Doc or ECO #:	ECO-PN4-003-004	Date:	2/16/2018	Author:	CH
	Rev. #:	C				
Pro4 Power Supply C7 Replacement and Thermistors Retention	Engineering Approval:	AEG	Date:	4/6/2018	Quality Approval	DO

P/N #:	PN4-003	Effective Date:	February 1, 2018
Title:	Pro4 Power Supply C7 Replacement and Thermistors Retention

Capacitor C7 on Pro4 power supply was replaced and inrush current limiter thermistors were secured to the PCB to increase reliability.

Figure 1: Thermistors fixed to the power supply PCB

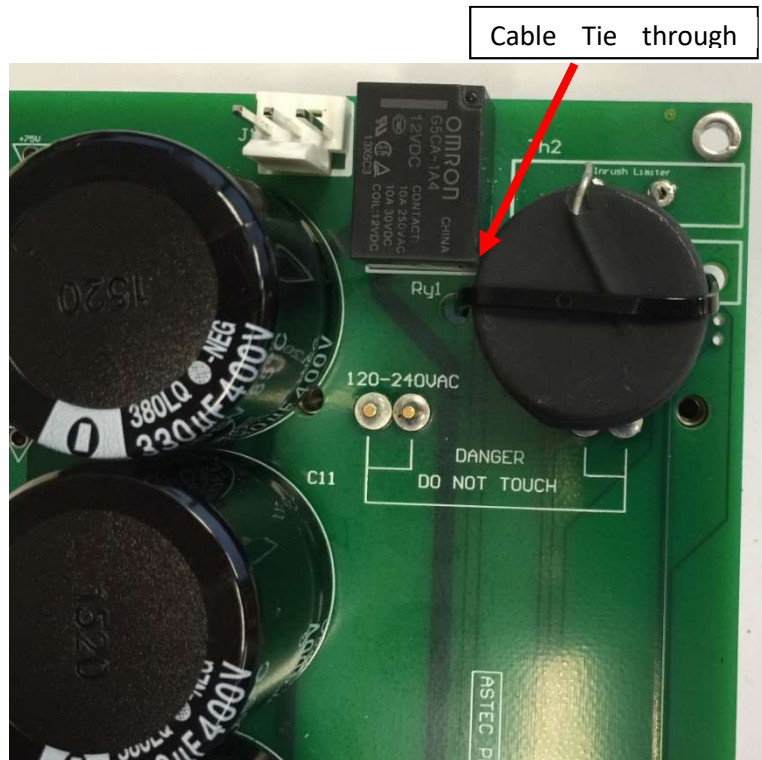
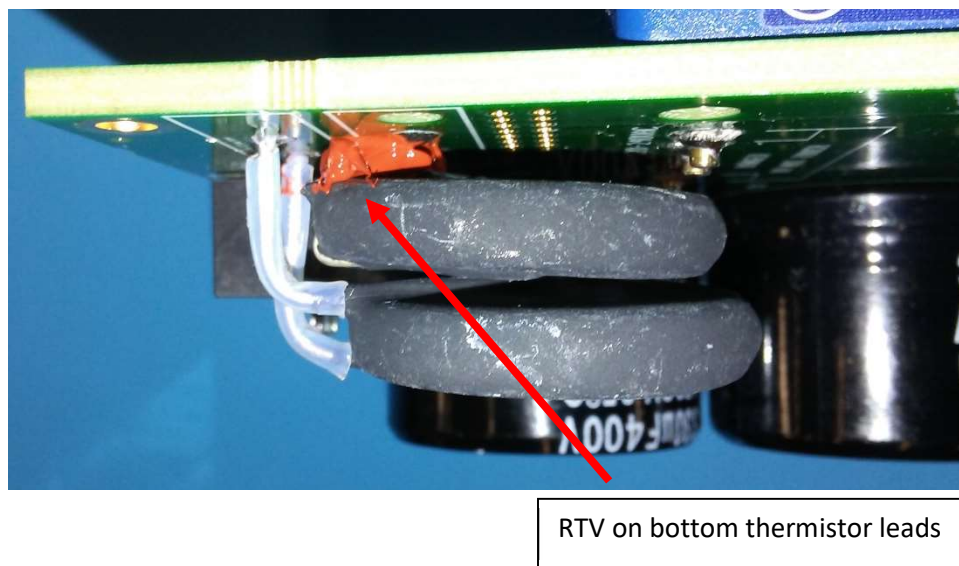
To improve power supply reliability, inrush current thermistors were fixed to the PCB with a cable tie. This will prevent the thermistors from breaking off the PCB during shipping.

Both thermistors will be bent into position to secure them to the PCB with an 8" cable tie. The top thermistor leads will be isolated with sleeves and the bottom thermistor leads will be isolated with high temperature RTV [52334] to prevent any shorts in the power supply.
